FINDING OF NO SIGNIFICANT IMPACT
Cantwell Subsistence Off-Road Vehicle Management Environmental Assessment
Denali National Park and Preserve, Alaska
September 2007

The National Park Service (NPS) prepared an environmental assessment (EA) to evaluate a proposal to manage subsistence-related off-road vehicle use in the Cantwell Traditional ORV Use Area (TUA) of Denali National Park and Preserve, Alaska.

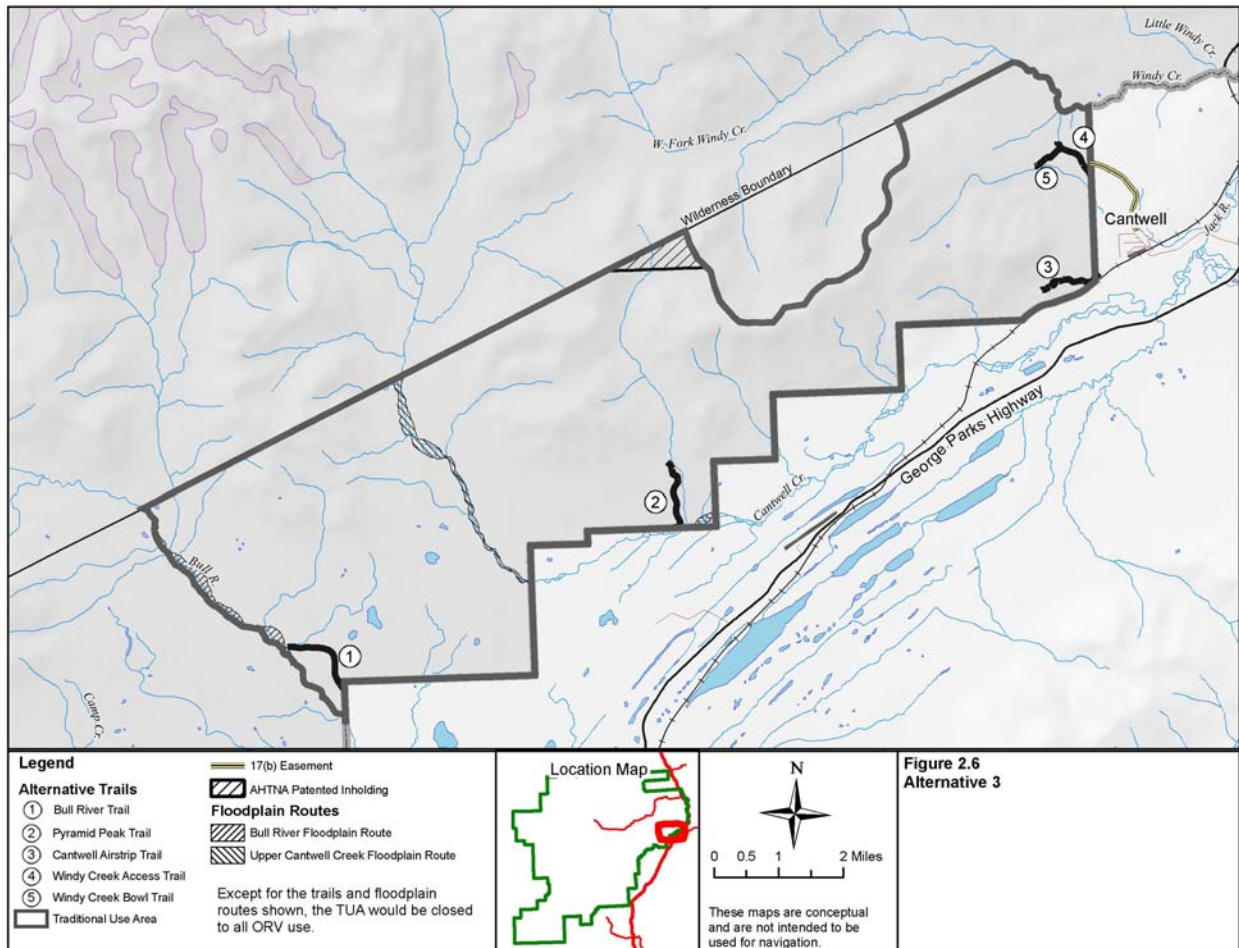
The NPS decision is to select a modified Alternative 3, NPS Preferred Alternative, along with the mitigating measures. A summary of the modified Alternative 3 is described here and a map of this alternative is included at the end of this document.
